ARCHITECTURAL REVIEW BOARD MEETING

Thursday, January 25, 2024 at 7:00 PM

Meeting Date:	January 25, 2024
Agenda Title:	COA 23-91 – 206 Culpeper Street
Requested Action:	Review of proposal to remove the garage/basement level of the previously approved addition to the main house; to install a gable roof with no dormer for the previously approved addition; removing a portion of the previously approved breezeway; to replace wall face of existing retaining wall with brick; and to install new fencing on the southwest side of the property to match existing scalloped fencing at side porch.
Department / Agency Lead:	Community Development
Staff Lead:	Casey Squyres

Meeting Date:	January 25, 2024
Agenda Title:	COA 24-1 – 11 S. Second Street
Requested Action:	Review proposal to minimize the size of the previously approved (COA 22-152) back patio.
Department / Agency Lead:	Community Development
Staff Lead:	Casey Squyres

NEW REAR ELEVATION

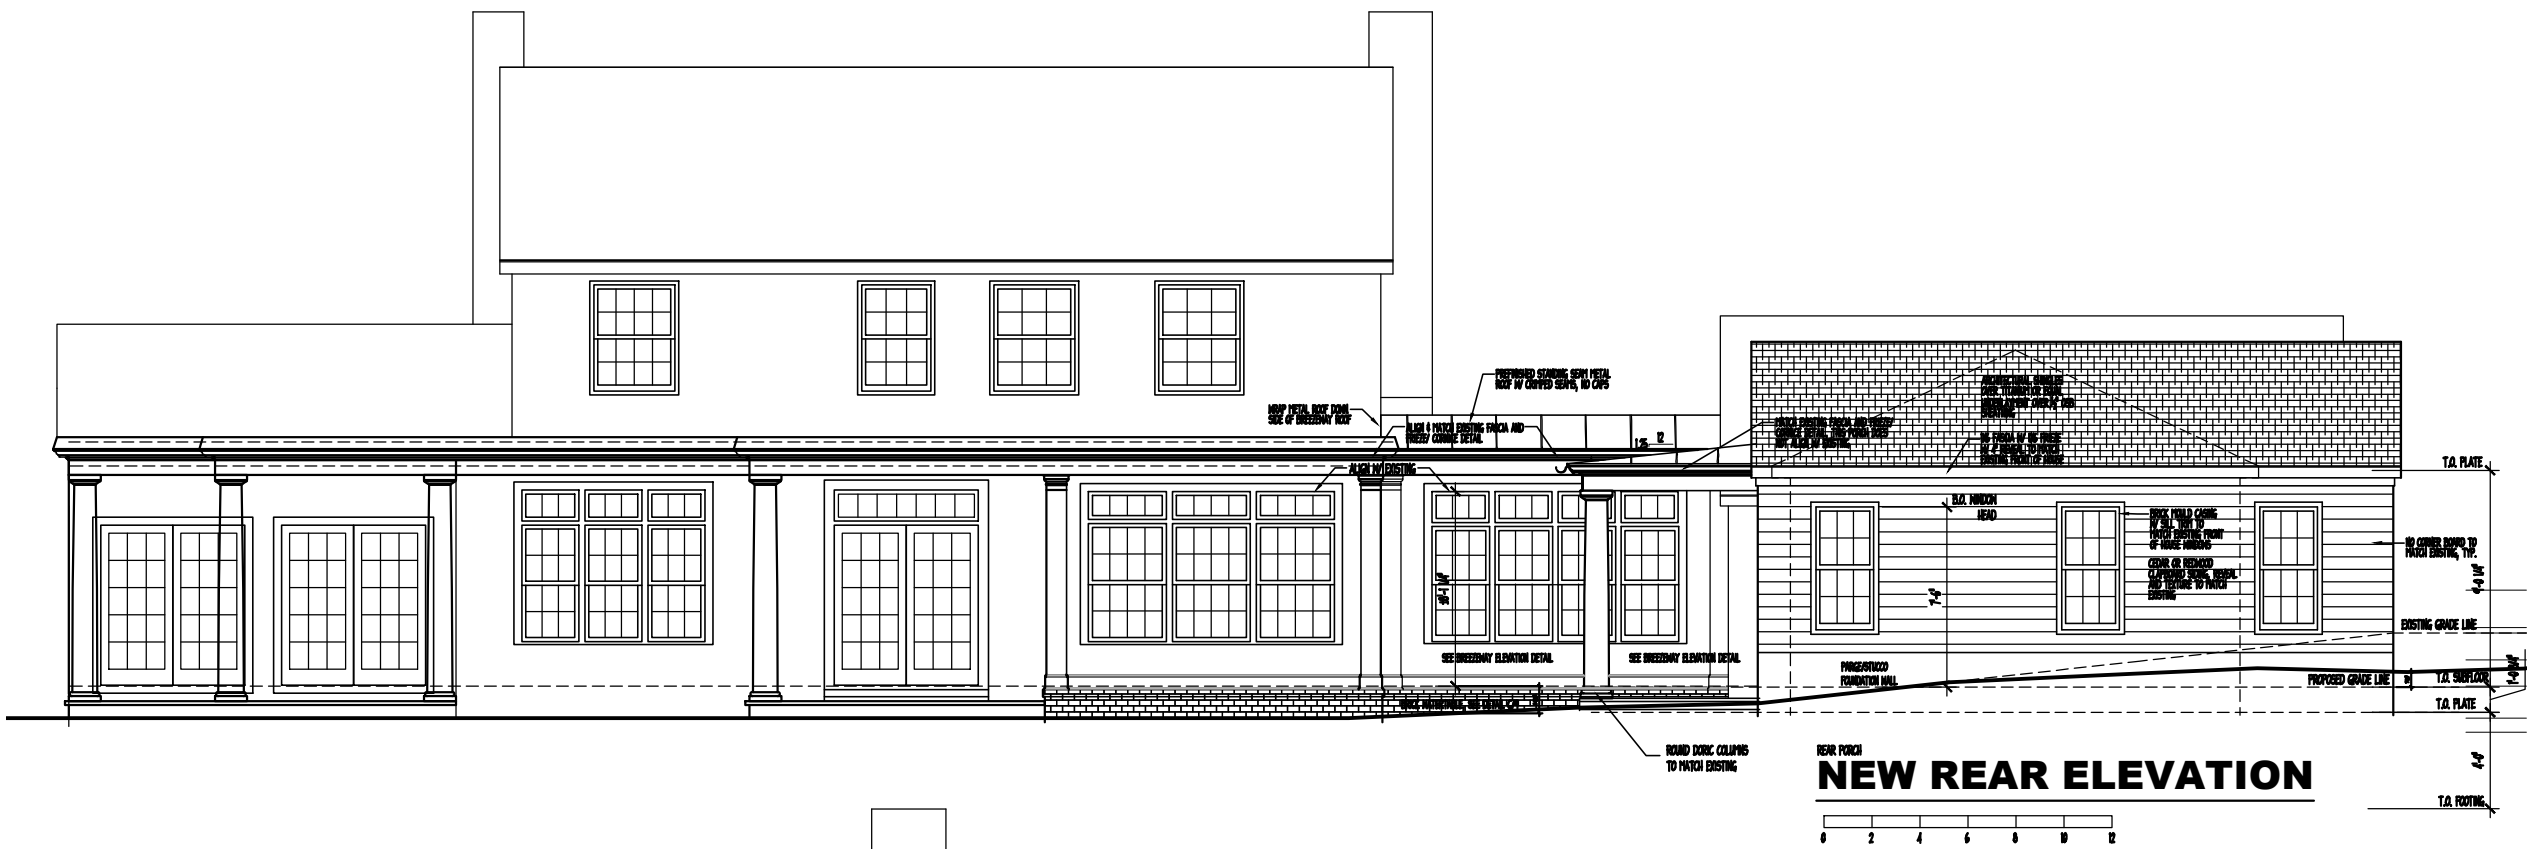
- **Breezeway on rear elevation reworked.**
 - The breezeway that was proposed in the original application has been reworked and a portion has been removed.

- None of the existing structure is being altered.
 - The new breezeway materials will be wood windows, wood trim to appear as columns and whitewashed brick water table to match the existing adjacent sitting room exterior.

Staff recommends approval of Certificate of Appropriateness 23-91 for the request to modify previously approved COA 23-45 to include the following modifications: 1) to remove the garage/basement level of the previously approved addition to the main house; 2) to install a gable roof with no dormer for the previously approved addition; 3) removing a portion of the previously approved breezeway; 4) to replace wall face of existing retaining wall with brick; and 4) to install new fencing on the southwest side of the property to match existing scalloped fencing at side porch, all as described and depicted within the application, at 206 Culpeper Street with the following conditions:

SECTION/ NEW SIDE VIEW

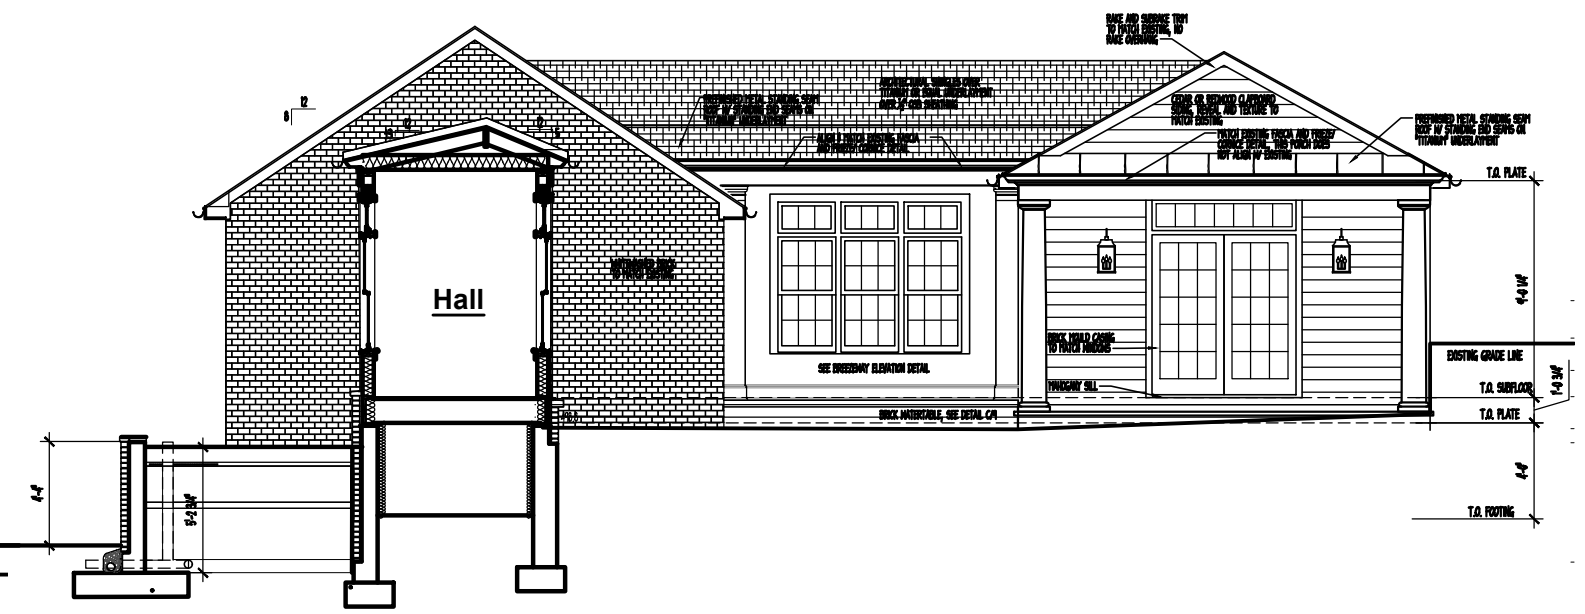
- **Remove Garage/basement level of addition.**
- **Exercise room and Laundry area reworked with gable roof and no dormer and white washed brick façade.**

Fencing:

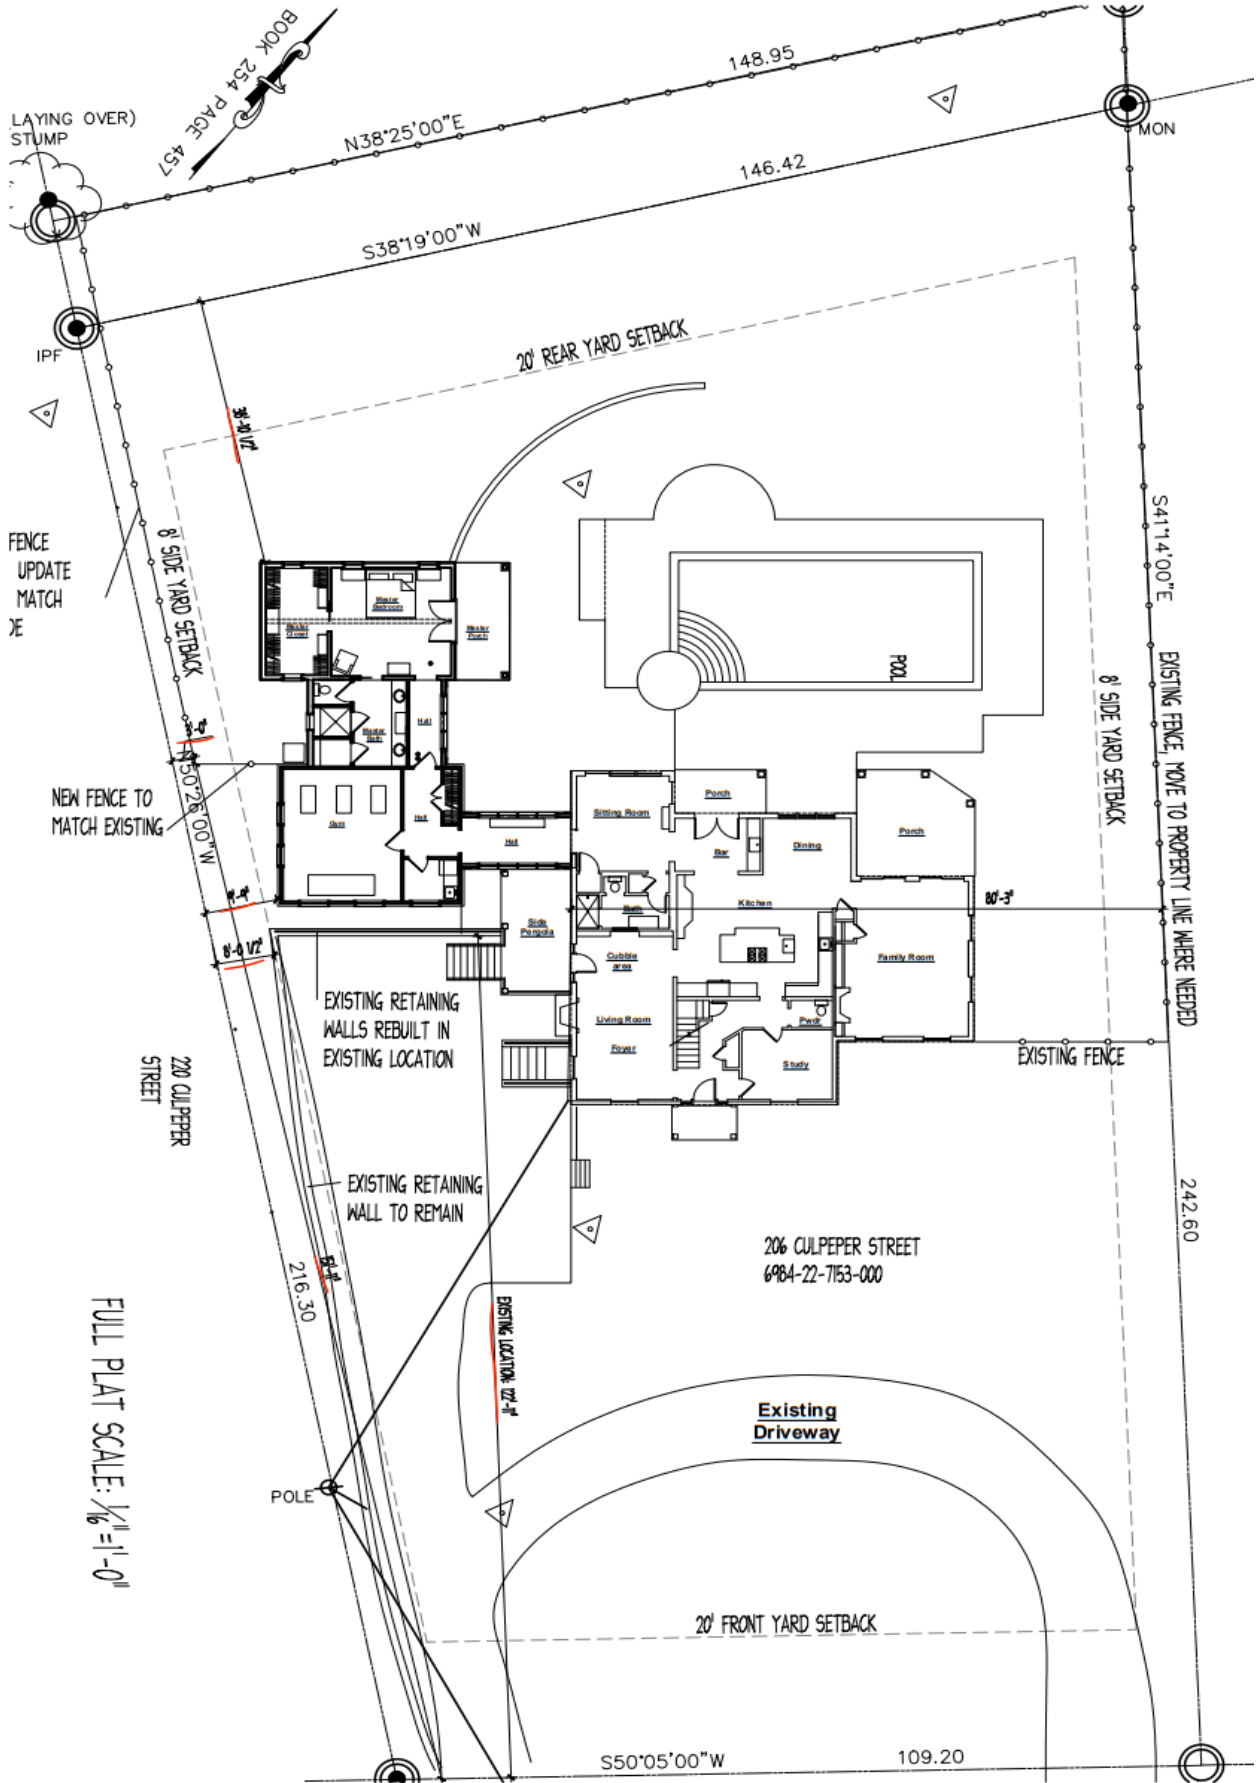
- New fence on southwest side to match existing scalloped fence. Currently three different styles of fencing exist on the property. The Applicant will be removing a wrought iron fence that was used for the pool access where the addition will be located and will be replacing the wood scalloped fence on the three sides of the backyard – this fence is currently deteriorating, and the Applicant would like more privacy with the pool by installing the new fence.

- These fences will be replaced to all match the wooden fence on the northwest (front) side of the property. The scalloped fence is painted wood with alternating vertical slats on front and back. It will match the existing height of around 6 ft at the highest point of the post scalloped down to the center at about 5 ft.

CURRENT PLAN (patio size cut back):

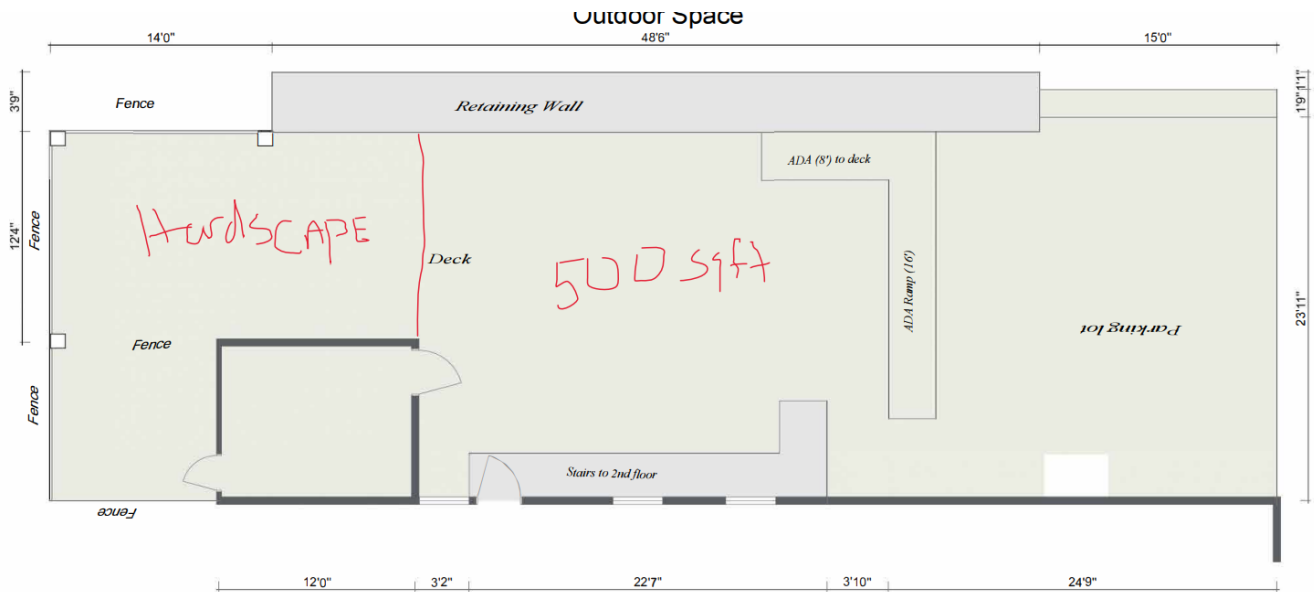
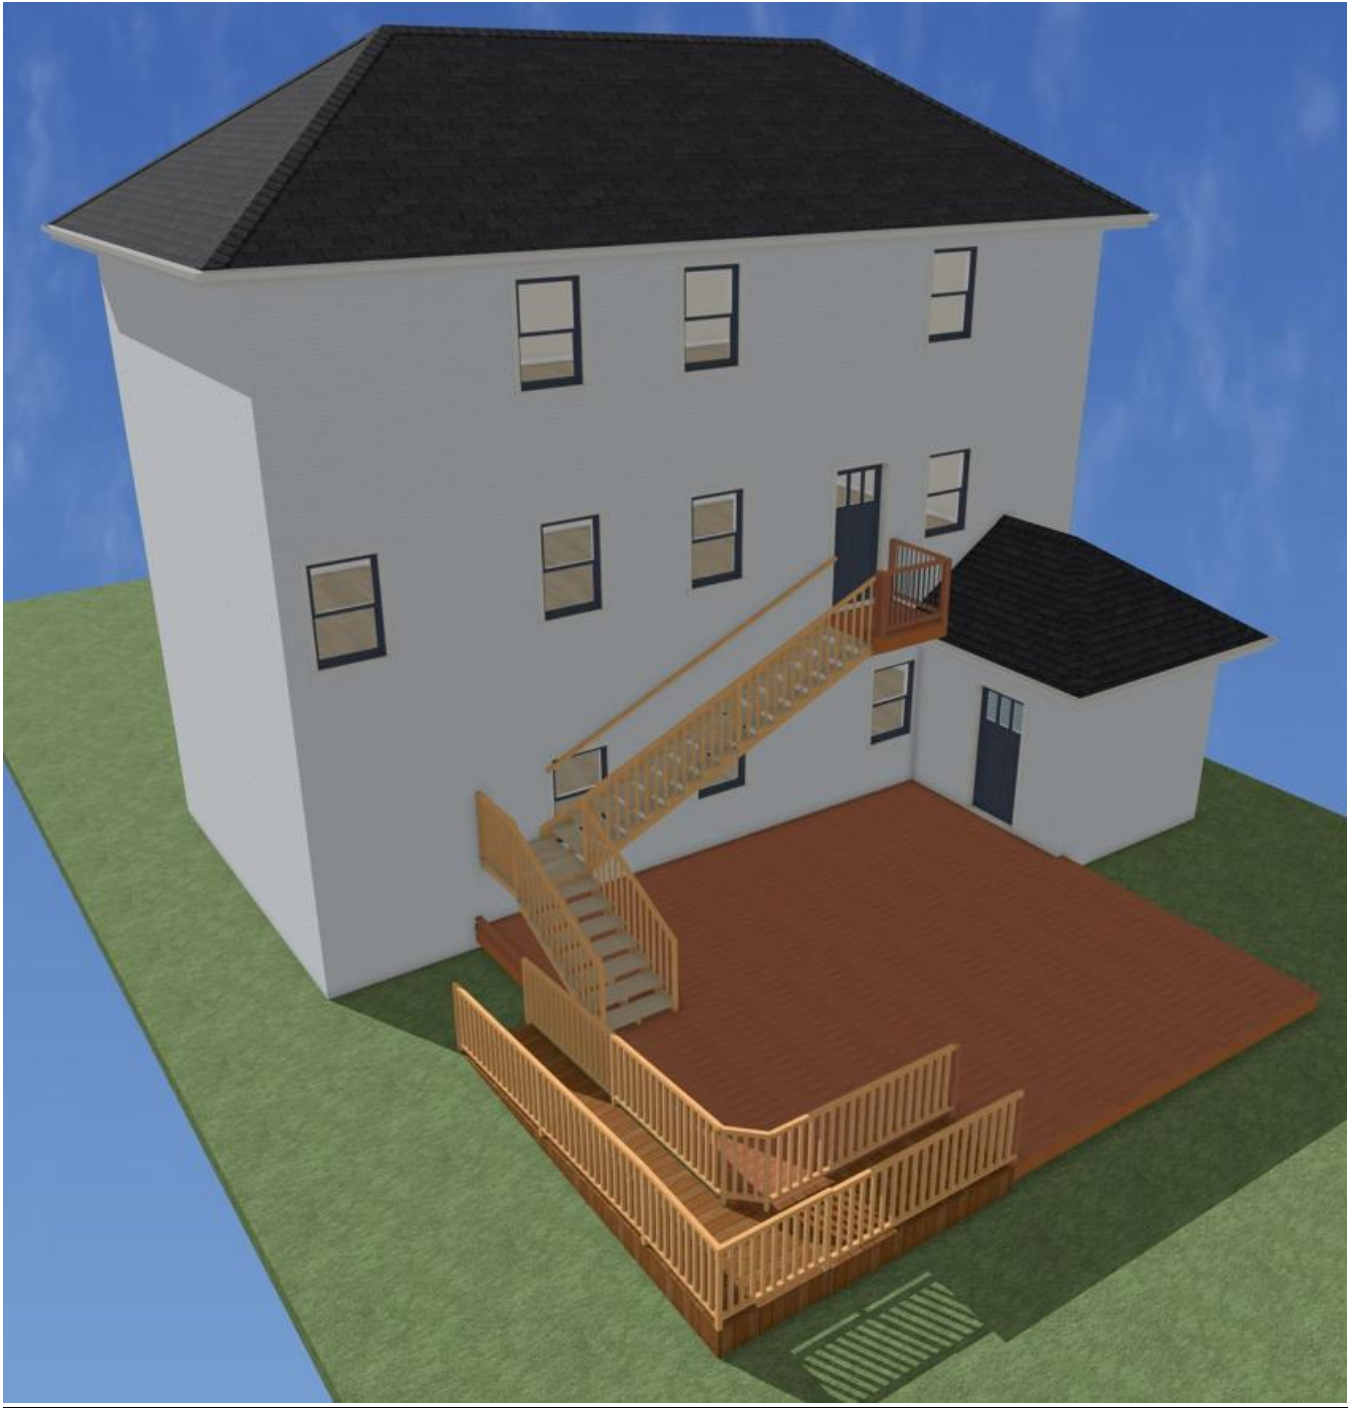
The Applicant is proposing to minimize the overall footprint of the previously approved (COA 22-152) back patio. The Applicant has confirmed that there will be no changes to the previously approved design or materials.

- The modified footprint will be a 575 Sqft deck in sealed natural wood with an ADA ramp and stairs (existing) to the 2nd floor.
- Previously it was a 55' long by 13' and 23' wide wood patio; 24" maximum height

Staff recommends approval of the request to modify previously approved COA 22-152 by minimizing the size of the side patio, as described and depicted within the application, provided the following conditions are met:
